NWRL ENVIRONMENT IMPACT ASSESSMENT NO.2

SUBMISSION ON CRITICAL ISSUES IDENTIFIED

Author: GURMEET SINGH

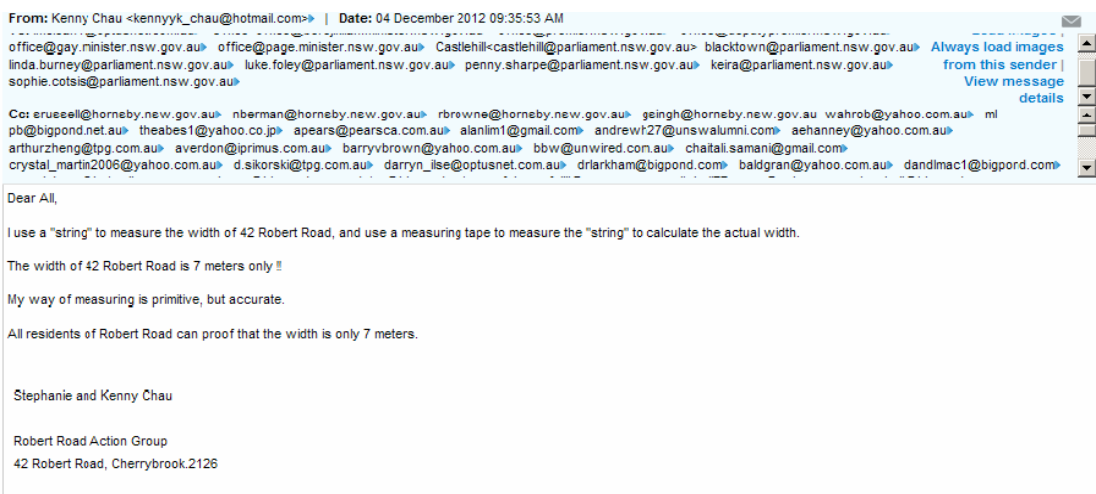
Robert Road is a narrow road with a carriageway width of 7.0 m (average) (kerb to kerb measurements) and not 8.5 metres as quoted in the report. As there is no survey and design drawings available from Council to validate the claim, Google Earth was used for ground truthing of the lane widths. It is a digitally acceptable method of ground truthing (although it is still approximate) but can be used for relative comparison of roads in absence of surveys or design drawings. It is widely used for concept design or preliminary design purposes only. The snapshots have been presented in Figure 2 along with rough calculations.

The carriageway width has been corroborated by residents living along the road (Refer below email from resident at 42 Robert Road, who has done the actual road measurement). There is no justification on how 8.5 m (although quoted approximate) was sourced from. This also contradicts the carriageway width of Robert Road quoted as 7.5 m in Chapter 9, Section 9.4.1.

It makes a significant difference the measured carriageway width has on classification and traffic modelling of road. A 9.0 m carriageway width is classified as "Local Road or Street" with two travel lanes and two parking lanes. Some of the adjoining roads that fit into the category are John Road and Franklin Road (although this has been quoted as 2 lane road in Technical Report 2). It appears there is lot of inconsistency in what is quoted and used for analysis in Technical Report 2 as compared to actual figures. In my opinion this is technical flaw or error unless it is justified by the consultant. Note my assessment is based on what I see in the report.

Visual view of the Robert Road, Not to Scale

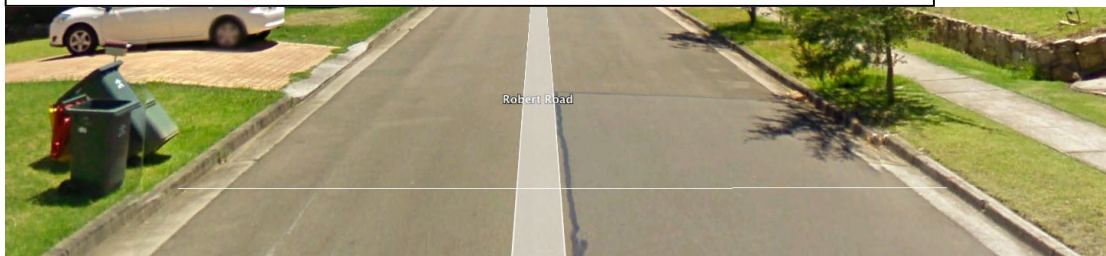
ROAD WIDTH IDENTIFIED FROM GOOGLE MAP IS 7.0 M. THIS WIDTH IS OPEN FOR VERIFICATION AND GROUND TRUTHING USING SURVEY OR ACTUAL MEASUREMENTS.

THIS WIDTH HAS BEEN CORROBORATED BY RESIDENTS LIVING ALONG THE ROAD AND CURRENT TRAFFIC CONDITIONS (SEE PHOTOS IN APPENDIX A)

Extract from EIS, Chapter 9, Section 9.5.2

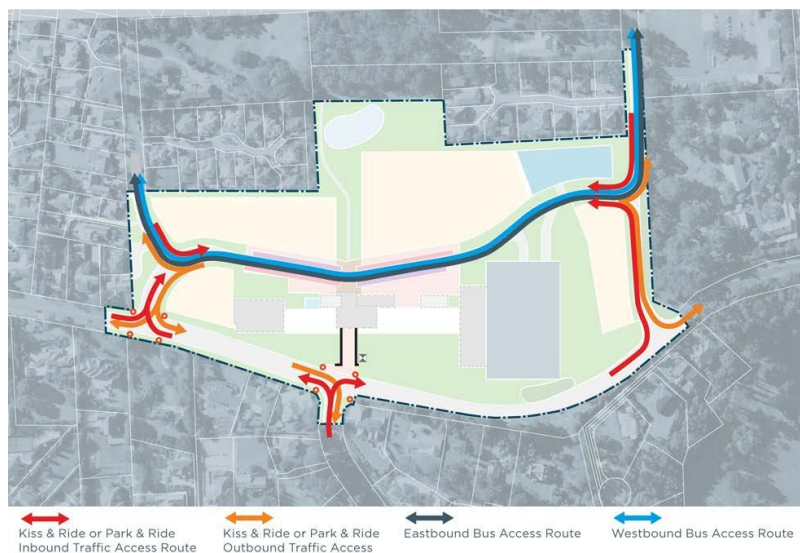
As mentioned, the major arguments/assumptions for using Robert road as the main feeder road to the station seem to be that County Drive and Castle Hill roads cannot be used as the main feeder route to the station because:

- There is a need to maintain bus stops along John Road, and*
- The intersection of County Drive and Castle Hill road is already saturated with traffic so buses cannot use County Drive.*
- Robert Road is well below its traffic capacity and can handle far more traffic.*
